PIC24FJ256GB110 Family Silicon Errata and Data Sheet Clarification

The PIC24FJ256GB110 family devices that you have received conform functionally to the current Device Data Sheet (DS39897C), except for the anomalies described in this document.

Data Sheet Clarifications

The following typographic corrections and clarifications are to be noted for the latest version of the device data sheet (DS39897C):

FIGURE 2-3 FREQUENCY vs. ESR PERFORMANCE FOR SUGGESTED VCAP

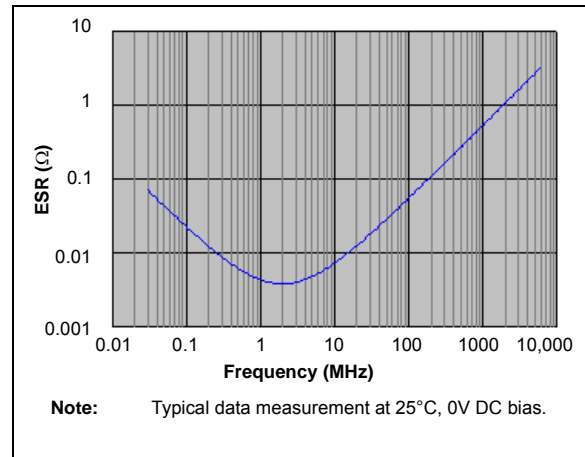
Section 2.4 Voltage Regulator Pins (ENVREG/DISVREG and VCAP/VDDCORE) has been replaced with a new and more detailed section. The entire text follows:

When the regulator is enabled, a low-ESR (< 5Ω) capacitor is required on the VCAP/VDDCORE pin to stabilize the voltage regulator output voltage. The VCAP/VDDCORE pin must not be connected to VDD and must use a capacitor of 10 μF connected to ground. The type can be ceramic or tantalum. Suitable examples of capacitors are shown in **Table 2-1**. Capacitors with equivalent specifications can be used.

Designers may use **Figure 2-3** to evaluate ESR equivalence of candidate devices.

FIGURE 2-4 DC BIAS VOLTAGE vs. CAPACITANCE CHARACTERISTICS

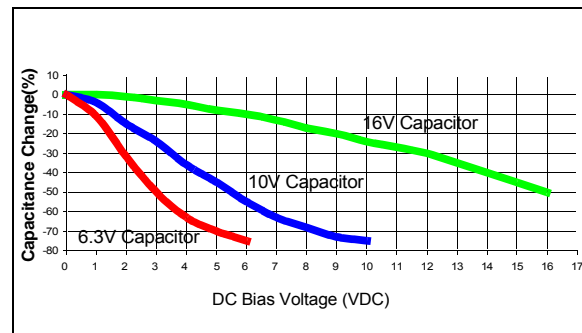
In addition to temperature tolerance, the effective capacitance of large value ceramic capacitors can vary substantially, based on the amount of DC voltage applied to the capacitor. This effect can be very significant, but is often overlooked or is not always documented.

A typical DC bias voltage vs. capacitance graph for 16V, 10V and 6.3V rated capacitors is shown in Figure 2-4.

When selecting a ceramic capacitor to be used with the internal voltage regulator, it is suggested to select a high-voltage rating, so that the operating voltage is a small percentage of the maximum rated capacitor voltage. For example, choose a ceramic capacitor rated at 16V for the 2.5V core voltage. Suggested capacitors are shown in Table 2-1.
